Re: EPA Technical Comments on the Passive SSDS O&M Plan and SSDS Evaluation, 825 Stewart Avenue Sunnyvale, CA, TRW Microwave Superfund Site (CERCLIS ID# CAD009159088)

Technical Review of Proposed Modification to a Passive Vapor Intrusion Mitigation System Installed at the Former TRW Site, Sunnyvale, CA

Re: Northrop Grumman Vapor Intrusion Work Plan Addendum #3. Former TRW Microwave Site, 825 Stewart Dr., Sunnyvale, California, TRW Microwave Superfund Site (CERCLIS ID# CAD009159088)

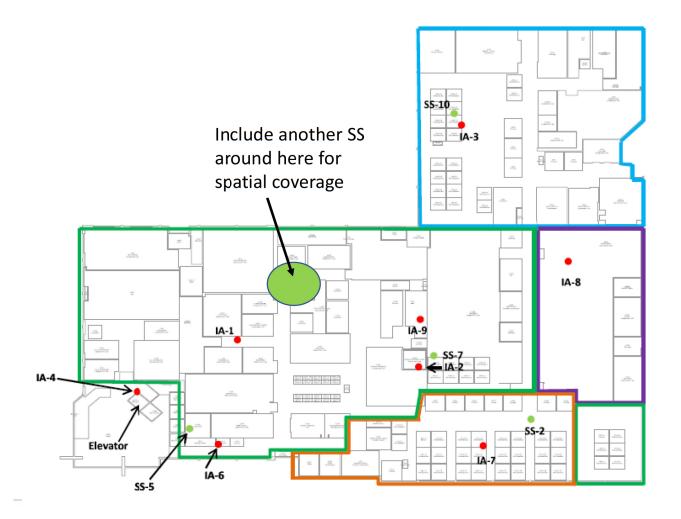
- 7. Include additional long-term (seven days) indoor air sampling using passive samplers in four locations (IA-2, IA-3, IA-4, IA-7). Include one long-term outdoor air sampling. Include a summary and SOP for the long-term passive sampling.

- 8. Include one additional sub-slab sampling location (SS-12) for spatial coverage as indicated in the figure attached.
- 9. Move sampling location IA-2 to the cubicles next to SS-7 (pending building walk through).
